A G E N D A
JAMES CITY COUNTY DEVELOPMENT REVIEW COMMITTEE
REGULAR MEETING
Building A Large Conference Room
101 Mounts Bay Road, Williamsburg, VA 23185
February 15, 2023
4:00 PM

**SITE PLAN-22-0051. Ironbound Crossing Wawa and Church Parking
Staff Report for the February 15, 2023, Development Review Committee**

TO: The Development Review Committee (DRC) of the
James City County Planning Commission
FROM: BCC at Watertower, LLC (Applicant)
RE: Appeal of Planning Director's Interpretation of Design Guideline Terms –
Landscape Edges and Hard Edges (SP-22-0051 Ironbound Crossing)
DATE: 31 January 2023

**SITE PLAN-22-0089. Chickahominy Riverfront Park RV Storage Lot
Staff Report for the February 15, 2023, Development Review Committee**

CONCEPTUAL DEVELOPMENT DIAGRAM

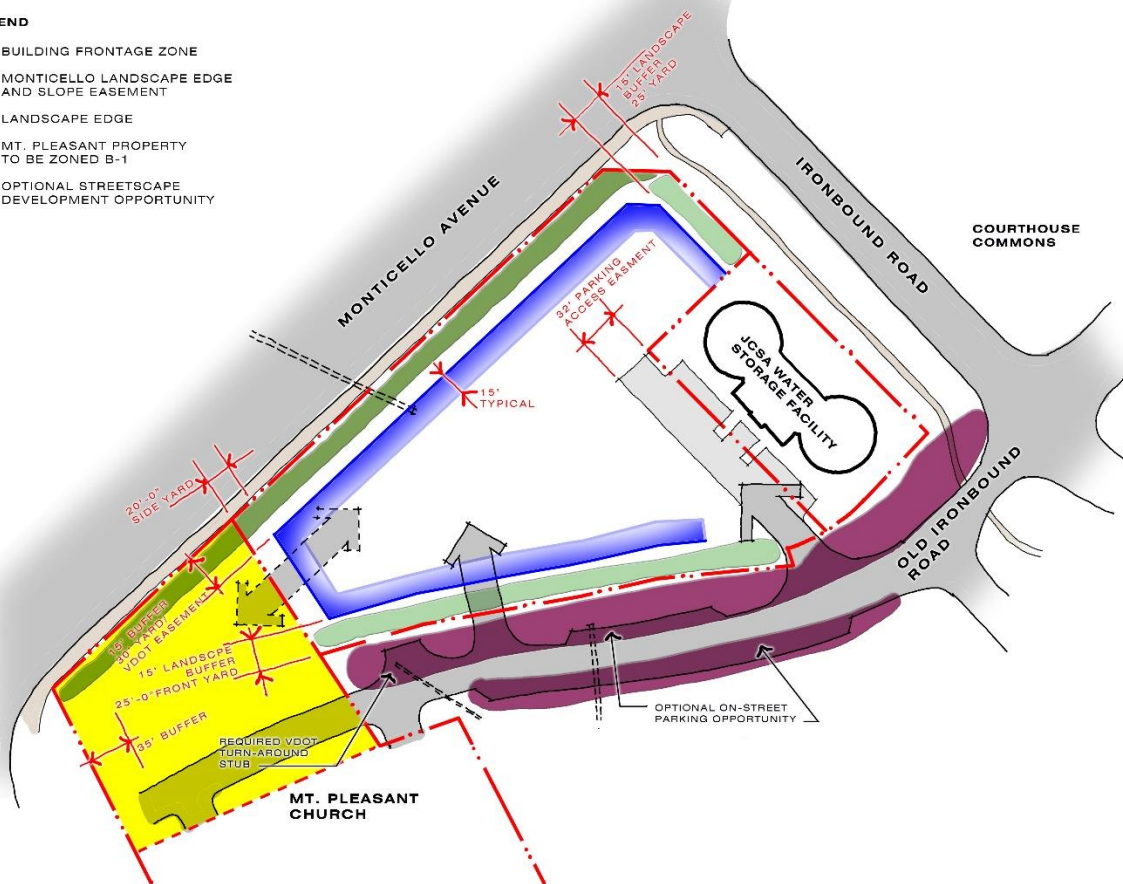
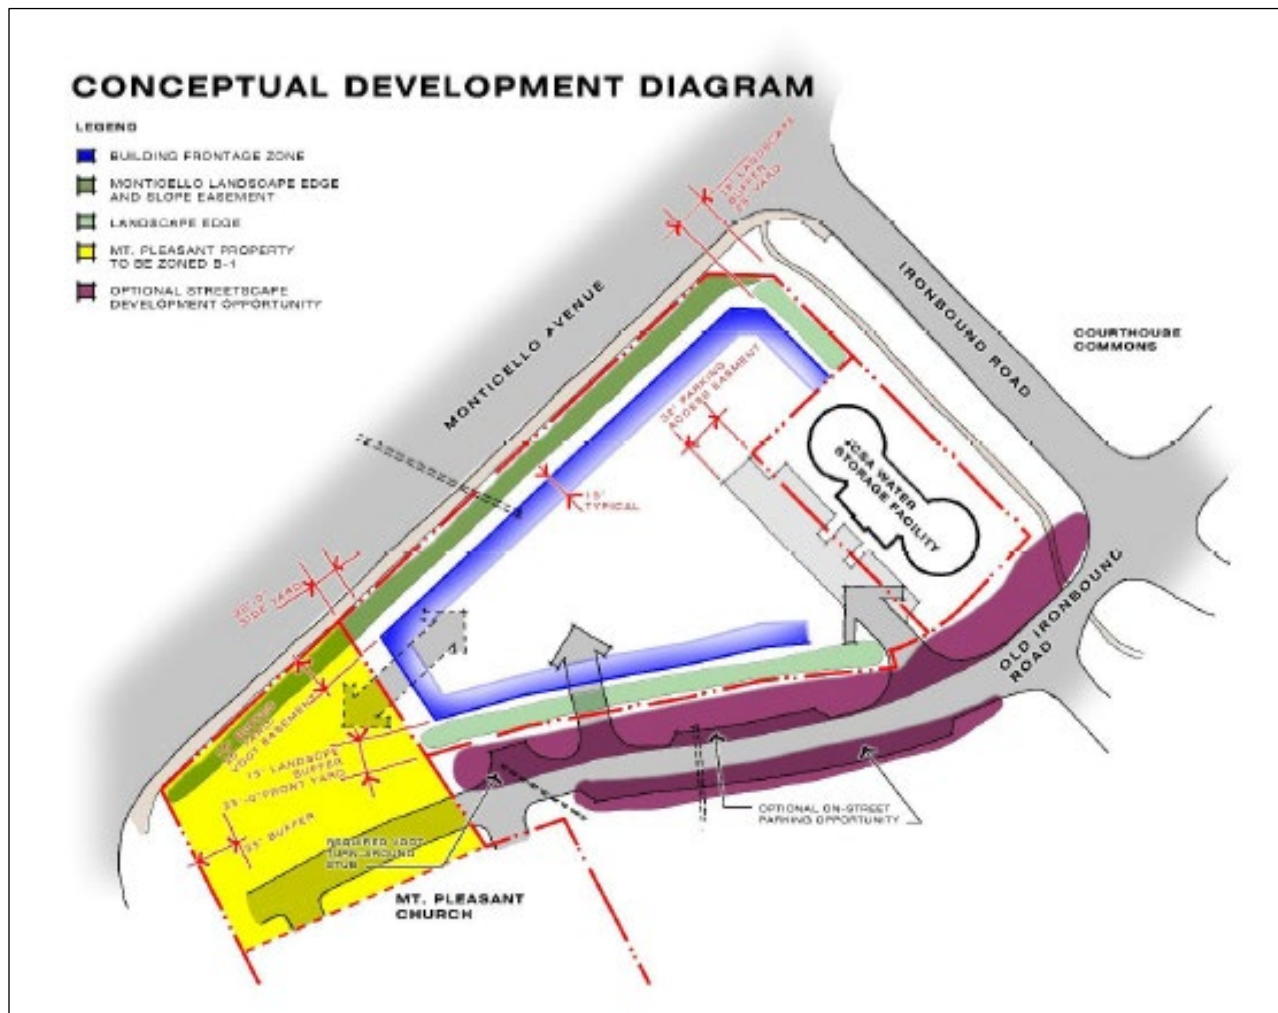
The Conceptual Development Diagram and associated notes found on page 6 of the Design Guidelines establishes the concept of frontage zones and landscape edges:

1. "Landscape Edges" are formal landscaped areas along property boundaries that may include a town-fence, retaining walls, hedges, etc.. Street trees are to be provided along Monticello, unless topography or other constraints would preclude them. These landscape edges create a foreground for building facades or, in the absence of a building façade, act to create a "hard edge" to the adjacent street.
 2. "Frontage Zone" is an area wherein at least 75% of a building façade must reside (except as indicated below, under "Street Design"). In the absence of a building façade, a "hard edge" of landscape elements must be provided in the adjacent "Landscape Edge."
 3. "Streetscape Development Opportunity" identifies off-street landscape, hardscape and parking which may be undertaken at the option of the developer, if approved by all jurisdictions having authority.
-

The notes on page 6 of the guidelines were included to establish and clarify the intent of both concepts. The objective of the text was to require a clear distinction (edge) between public property and the private development, and that this edge be of a "formal" nature. In the text, I use the phrase "hard edge", which is a term of art in urban planning (borrowed from painting) to refer to "formal" (as opposed to "organic" or "natural") organizational patterns. It does not imply or require a built site structure, such as a fence or wall, although those are options, as well as are hedges, street trees or other planted materials. The language describes how they are to be arranged, not what they are to be.

Project Contacts: GVC
Project Number: W10481-00
Scale: 1"=30'
Date: 06/01/2022
Sheet Title: LANDSCAPE PLAN

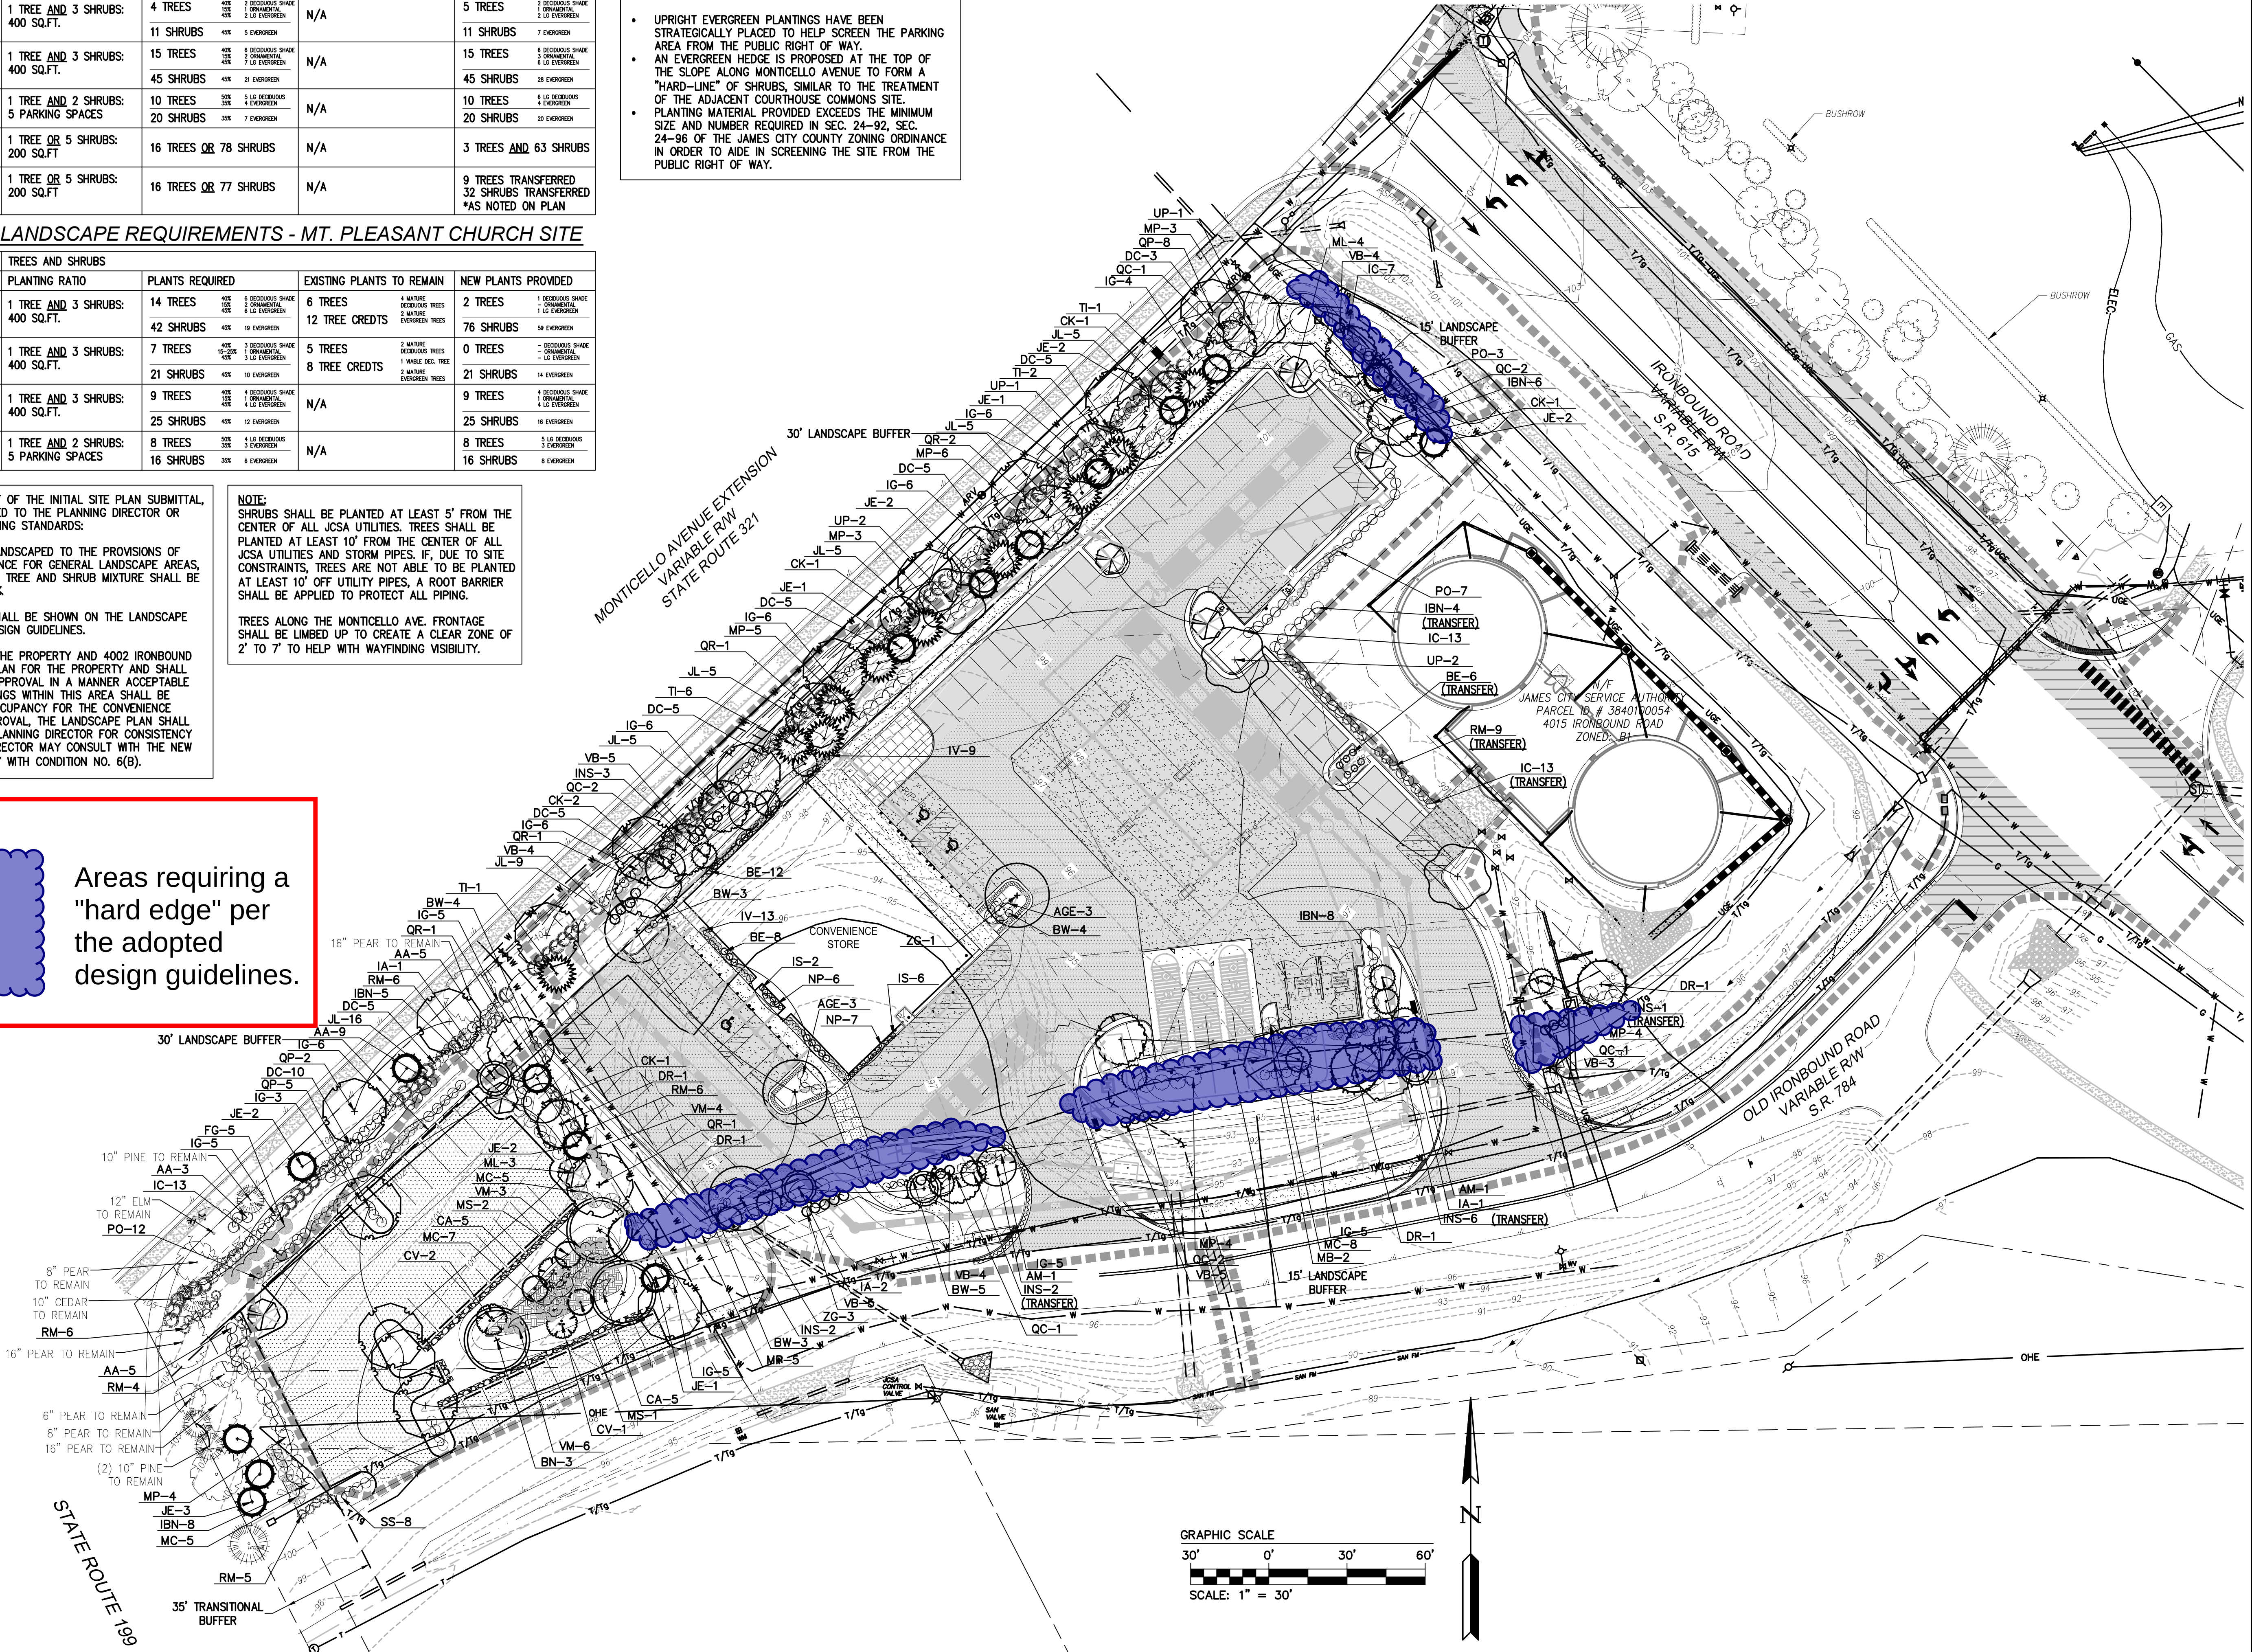
After review of the site plan, the Planning Director finds that the proposed row of landscape shrubs (in hedge row form) along Ironbound Road and Old Ironbound Road do not meet the requirement of a “structural site element, such as fencing or a wall or combination, or the equivalent” as required by the adopted design guidelines (Attachment No. 3) for the site.

Based on the above text, staff has requested that the areas along Old Ironbound Road and Ironbound Road of the site shall achieve a “hard edge” by providing a structural site element such as fencing or a wall or combination, or the equivalent. Rather than something constructed or erected, the applicant is requesting to provide a row of hedges along Ironbound Road and Old Ironbound Road to provide the referenced “hard edge”.

The Planning Director finds that the proposed hedges along Ironbound Road and Old Ironbound do not meet the requirements of the adopted design guidelines and that a structural site element is required. Staff recommends the DRC not approve the request.

The landscape plan shows formal landscaping treatments along all frontages, including the two road frontages in question. Thus, the definitions found on page 6 offer the needed clarity that is lacking from the subject sentence on page 7. The design guidelines themselves clearly allow for a finding that no wall or fence is required along Ironbound and Old Ironbound roads. The New Town DRB, in its required review of the Project, came to the same conclusion as the Applicant and asserted no requirement for fencing or a wall along either Ironbound Road or Old Ironbound Road.

For all of the above reasons, we respectfully request that the DRC find that the landscape plan, as submitted, is "...generally in accordance with the Design Guidelines.", as required by the Proffers accepted with Z-18-0006 and specifically that no fence or wall is required along Ironbound Road and Old Ironbound Road.

IRONBOUND CROSSING (SP-22-0051) LANDSCAPE EDGE EXHIBIT

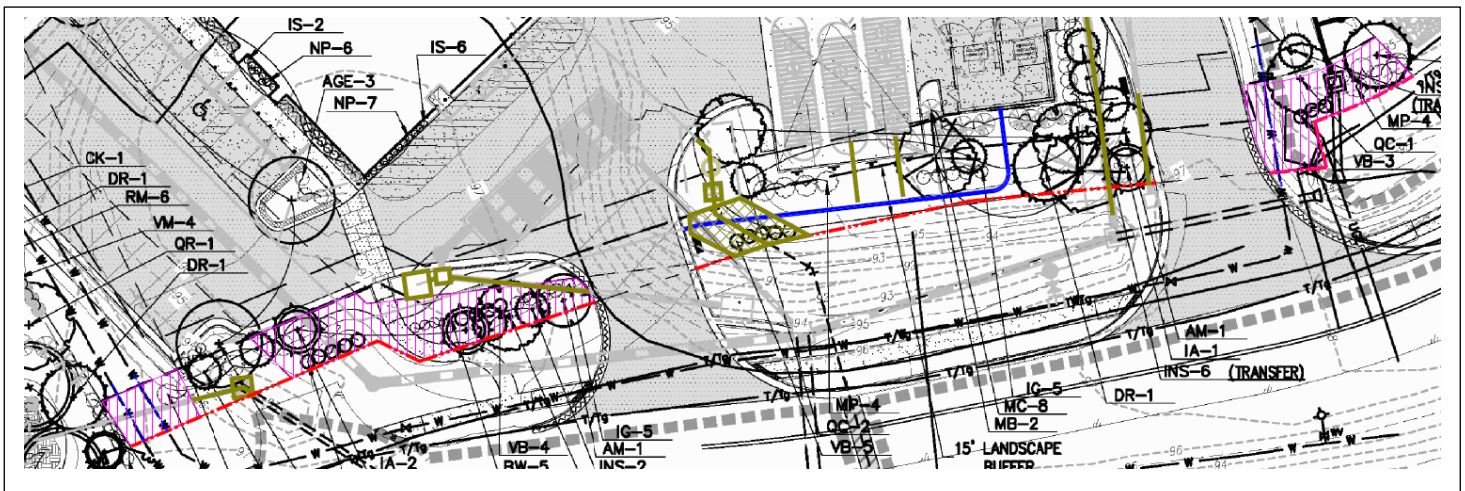
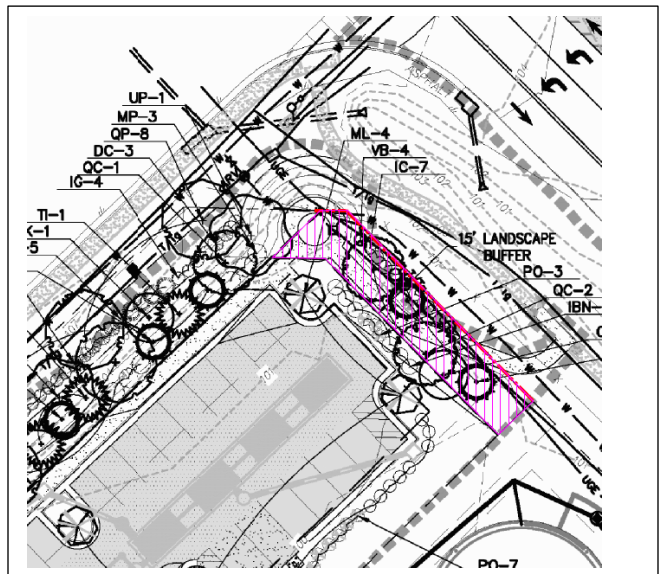
3. The JCSA Ironbound Water Storage Facility is proposed to be surrounded by (8) foot tall security fencing. The Applicant was requested to reflect this fencing on the Ironbound Crossing site plan. Such fencing is not appropriate for a convenience store site, but the JCSA fencing certainly serves to create a hard edge along both roadways.

4. For this relatively small in-fill site, there are many existing utilities and easements in the landscape edges along all roadway frontages (see below and attached) that would preclude the installation of fencing or walls across much of the landscape edge areas in question. Old Ironbound Road is particularly challenged. The dominant streetscape of Ironbound Road, between Monticello Avenue and Old Ironbound Road, will be the 8-foot tall JCSA security fencing across roughly two-thirds of the available frontage. Fencing or a wall across the relatively short length of available frontage at Ironbound Crossing would neither enhance the hard edge the design guidelines seek to achieve nor provide an appealing transition from the heavily landscaped Monticello Ave frontage of Ironbound Crossing to the Ironbound Road frontage soon to be dominated by the tall security fencing.
